REQUEST FOR INFORMATION	DATE: May 11, 2016	NO.: RFI-066
--------------------------------	---------------------------	---------------------

Project Name: Webster University Interdisciplinary Science Building Project No.: 15051

Subject: Plumbing penetrations through structural concrete

P0011

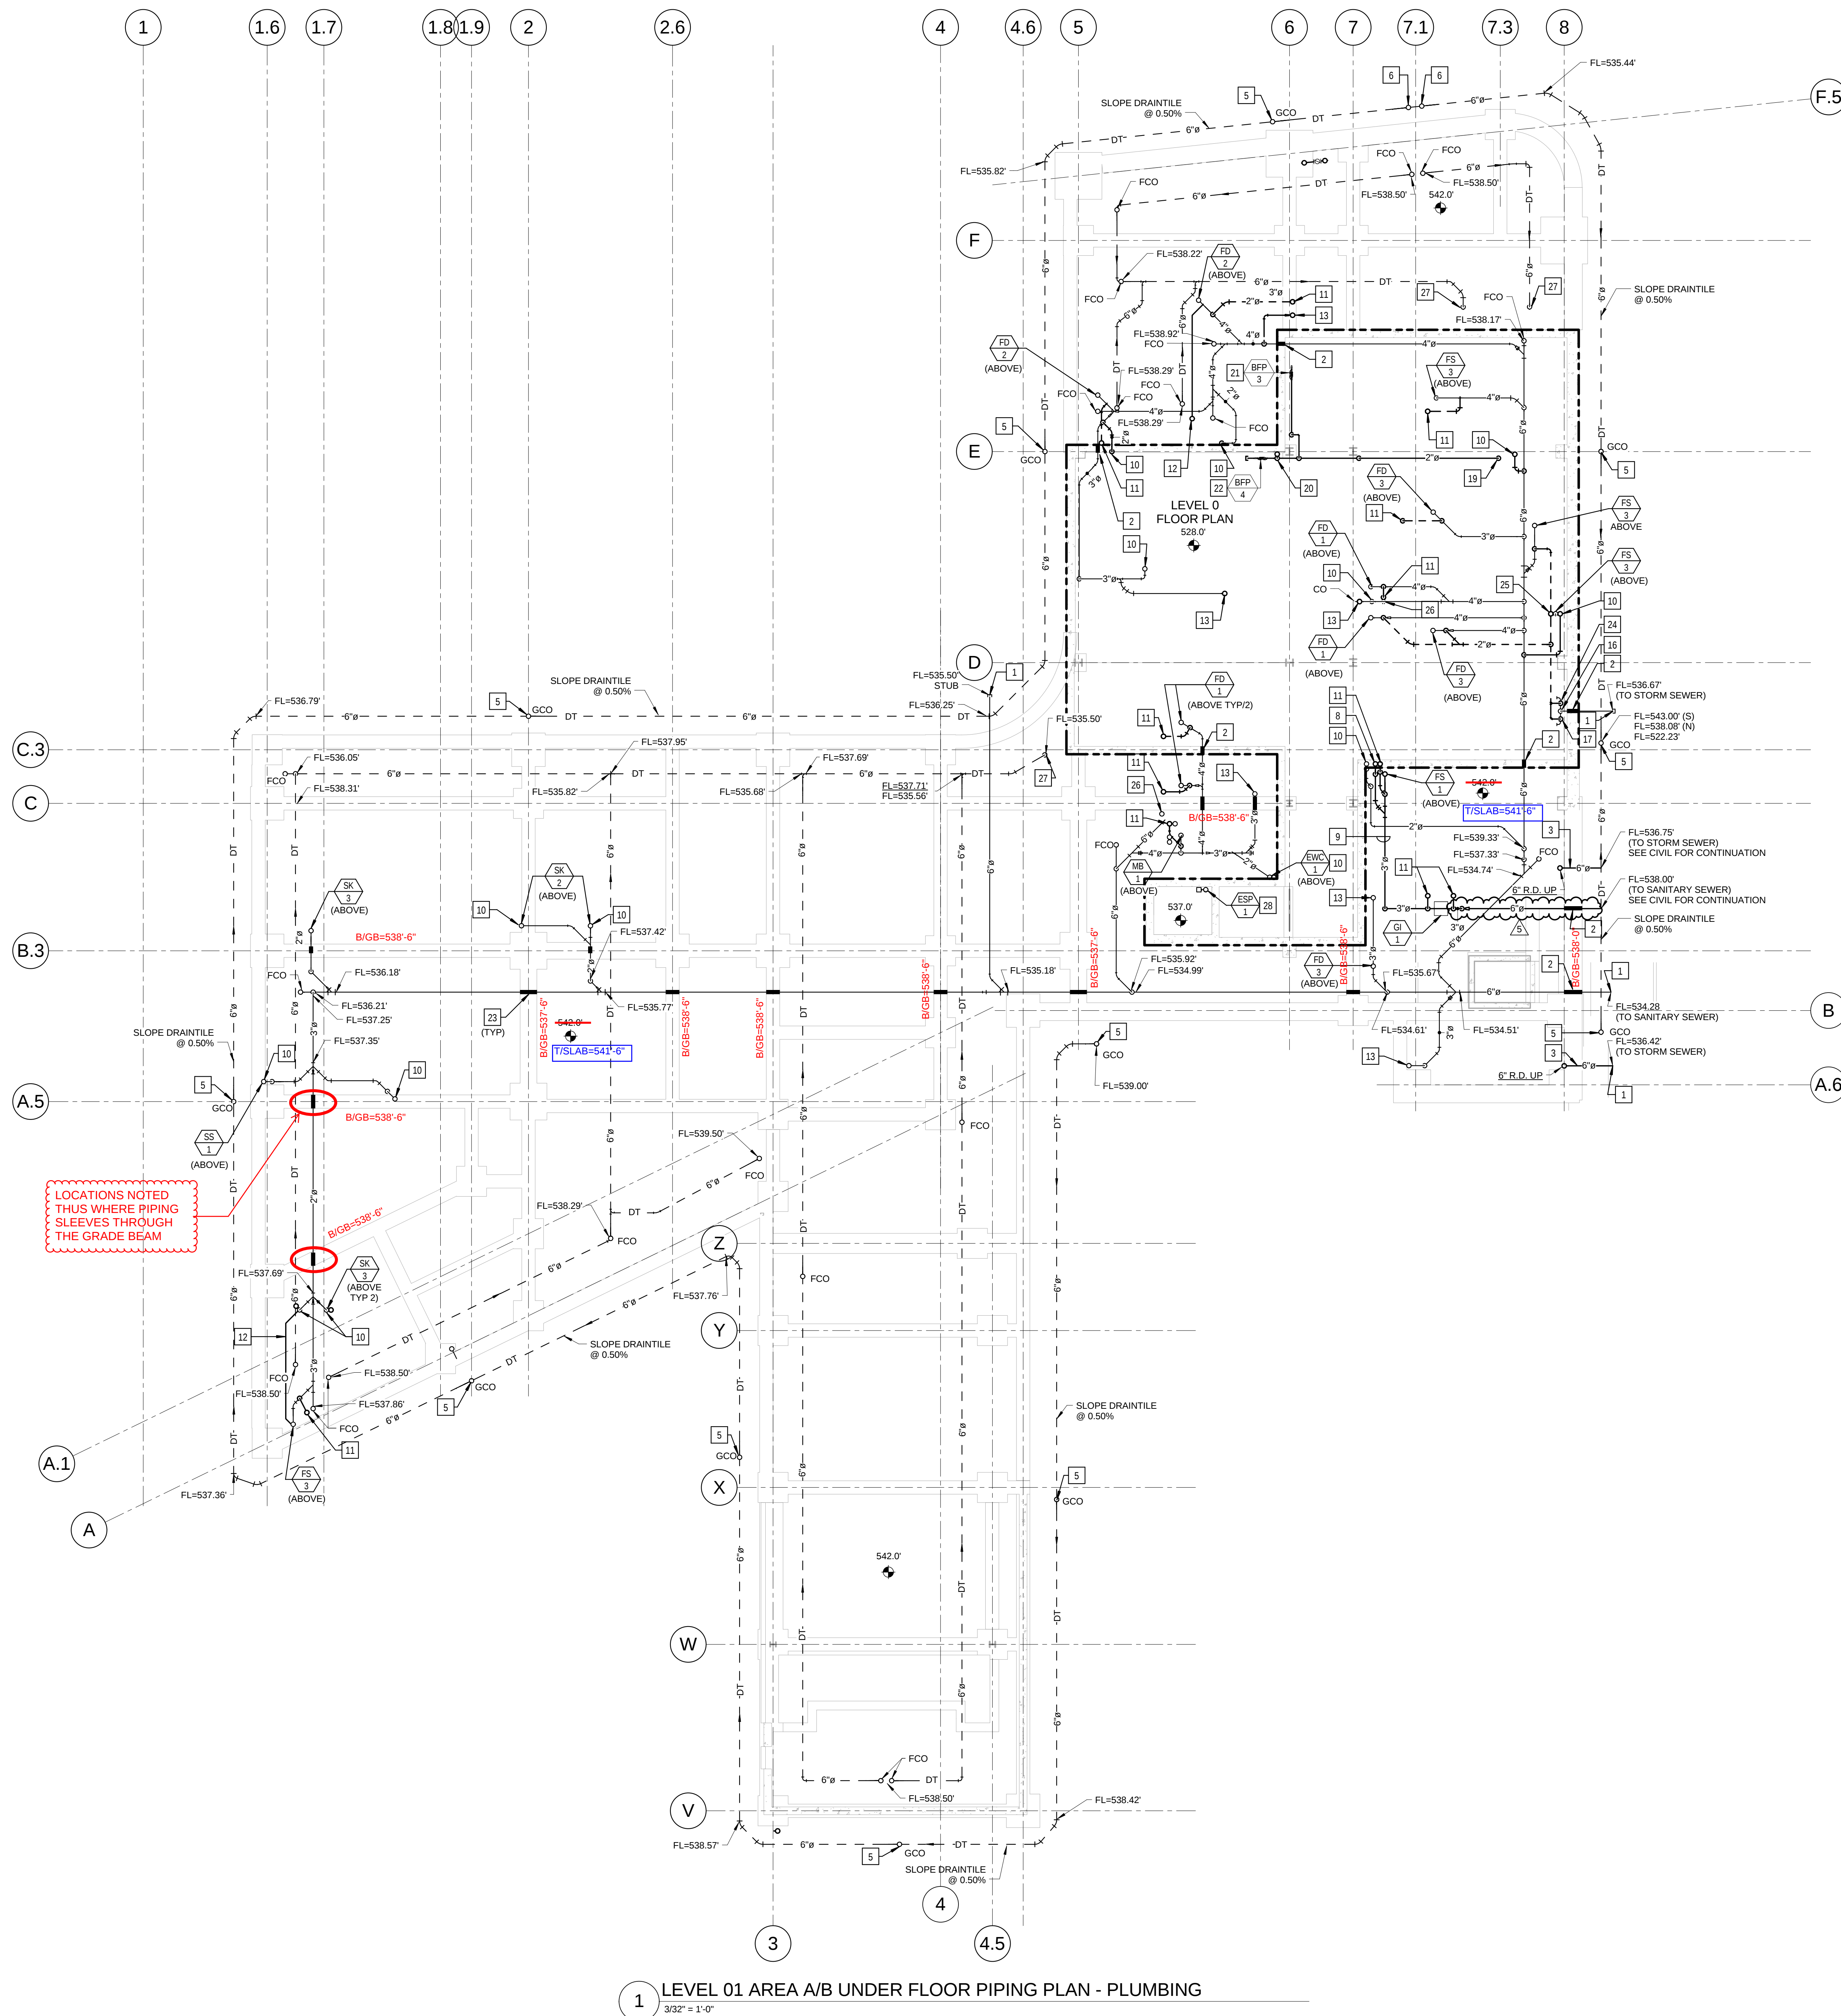
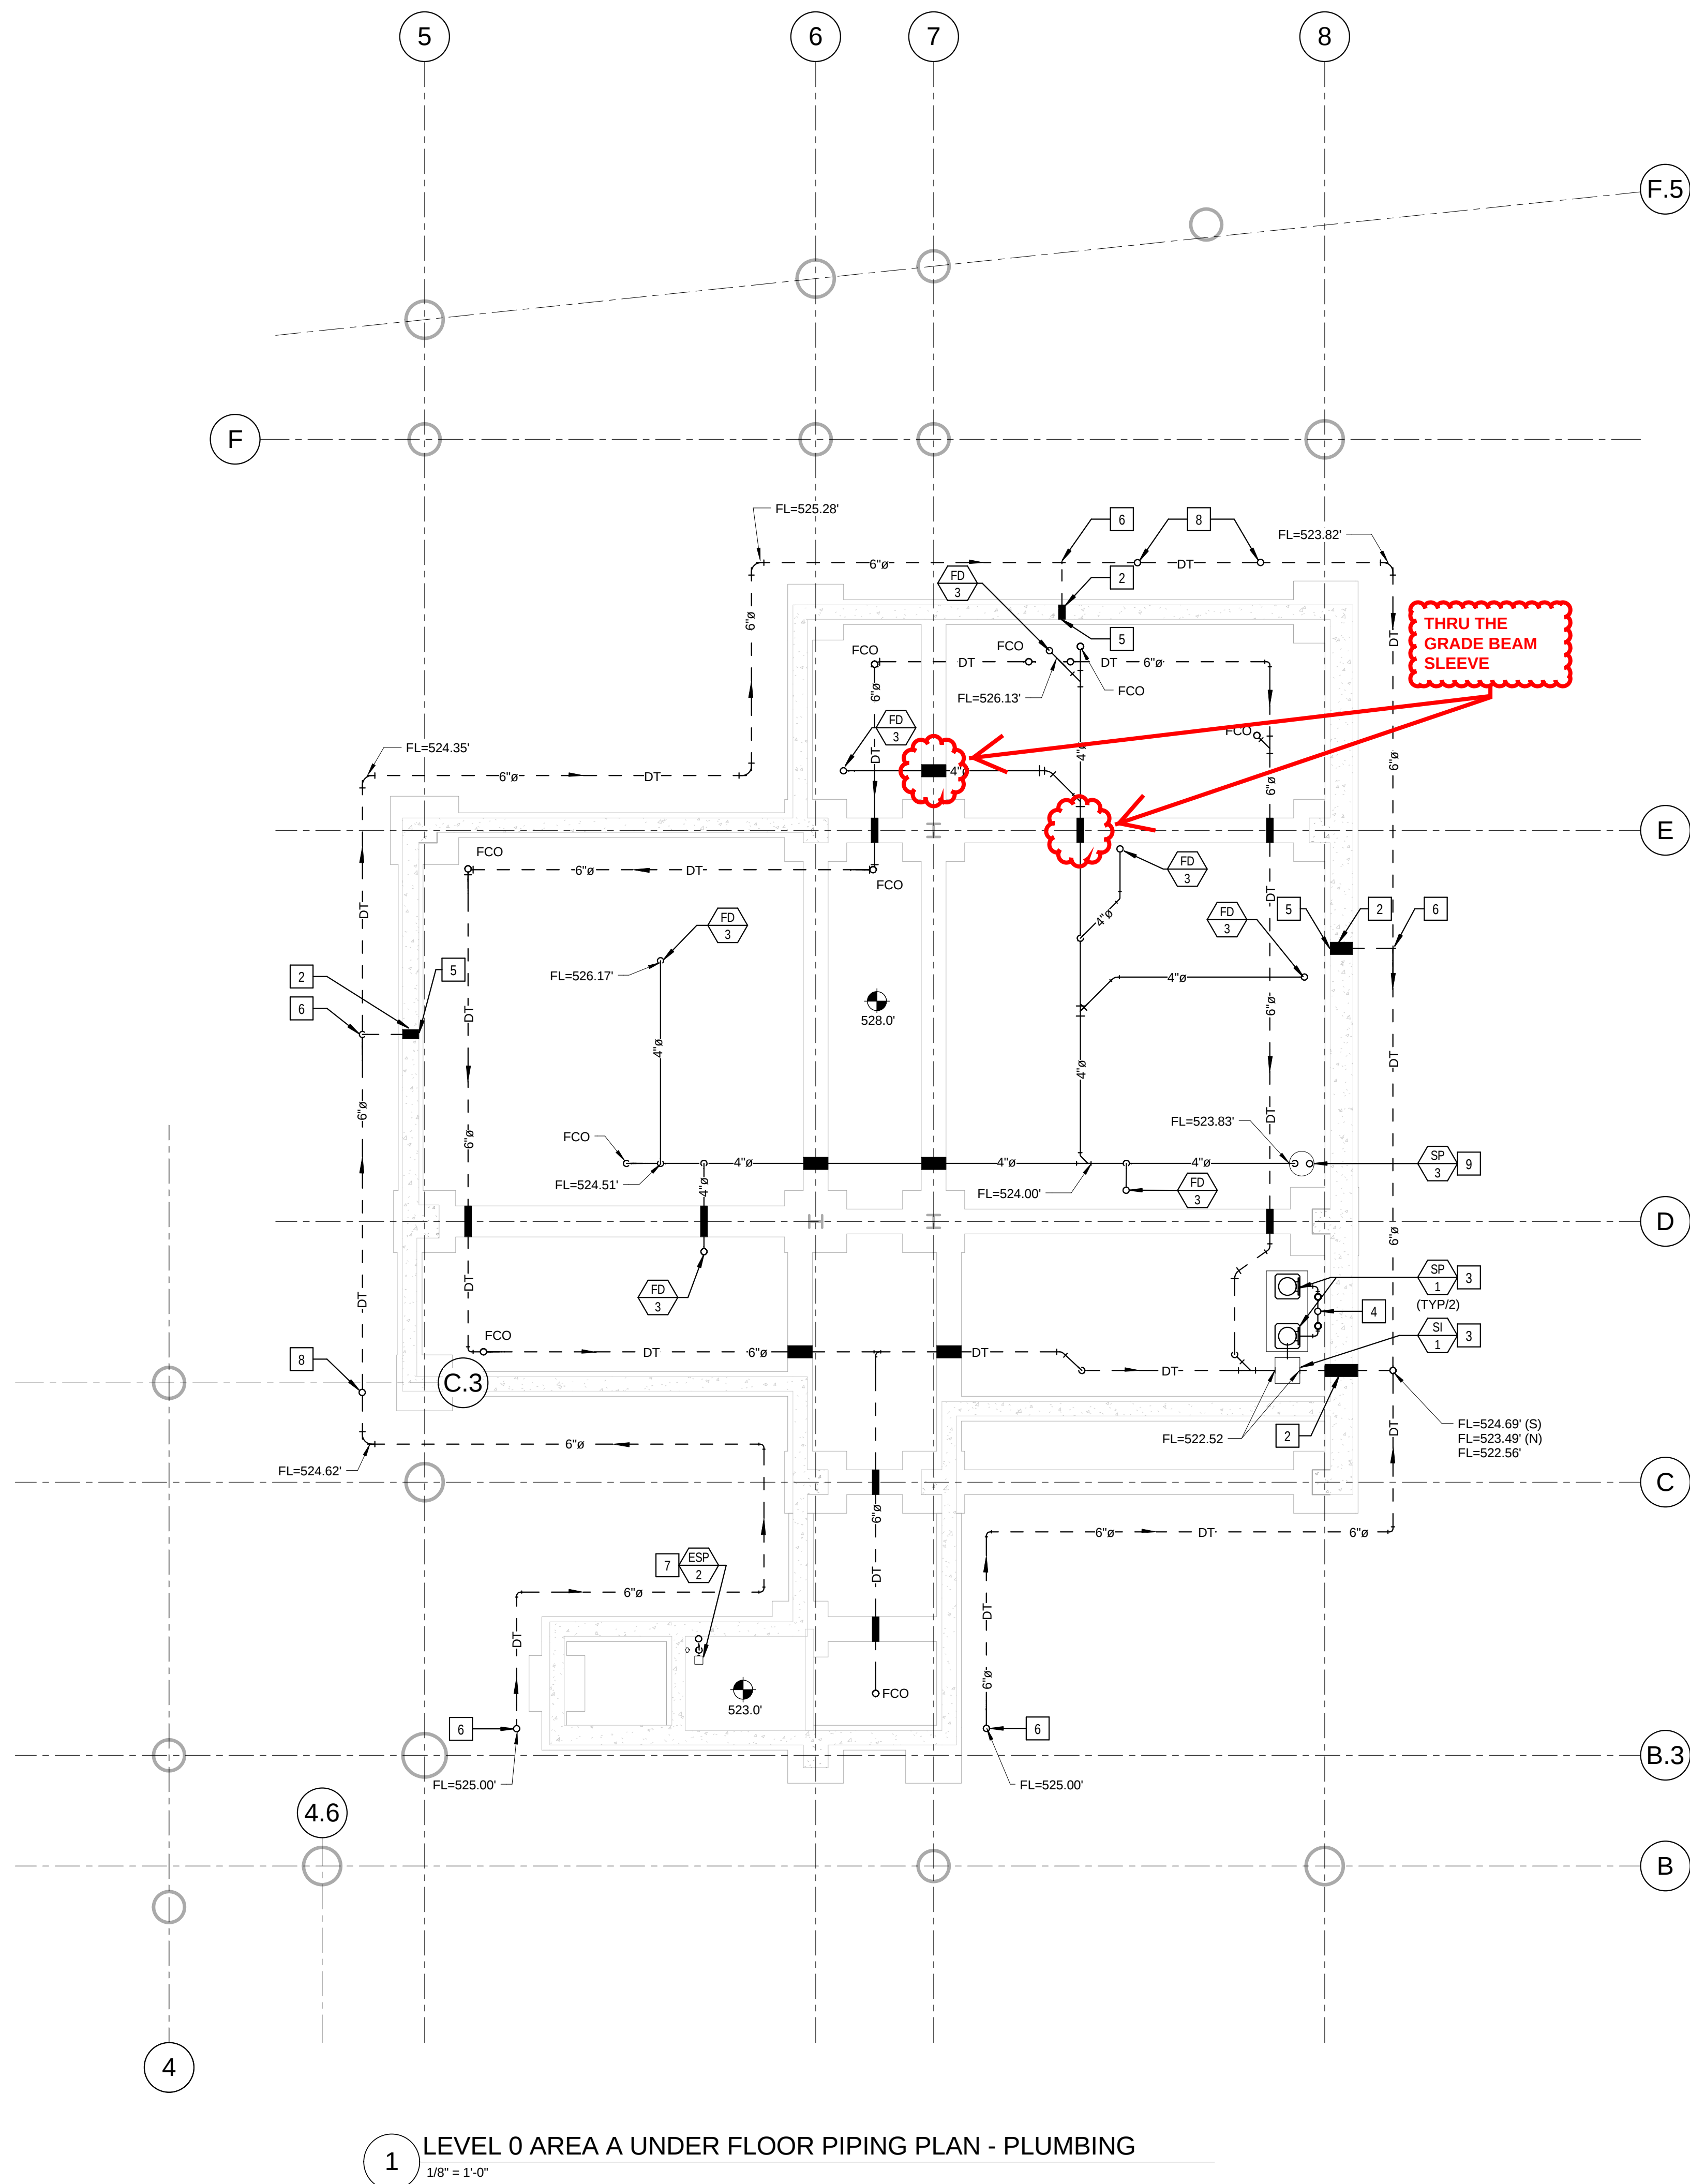
The plumbing drawings show multiple sleeves through the structural concrete. Please confirm these are approved by the structural engineer as shown.

Yes, there were sleeves which were coordinated with structural, but there were only a few. See 6/S0002 and 6/S0003. However, there are numerous locations shown on the plumbing drawings that should only require a protective steel conduit under the grade beam. The B/GB elevations are noted on the two lower level plumbing drawings. These have been coordinated with plumbing and their markups are also attached for reference as provided by Mike Whitworth / WEBB Engineering.
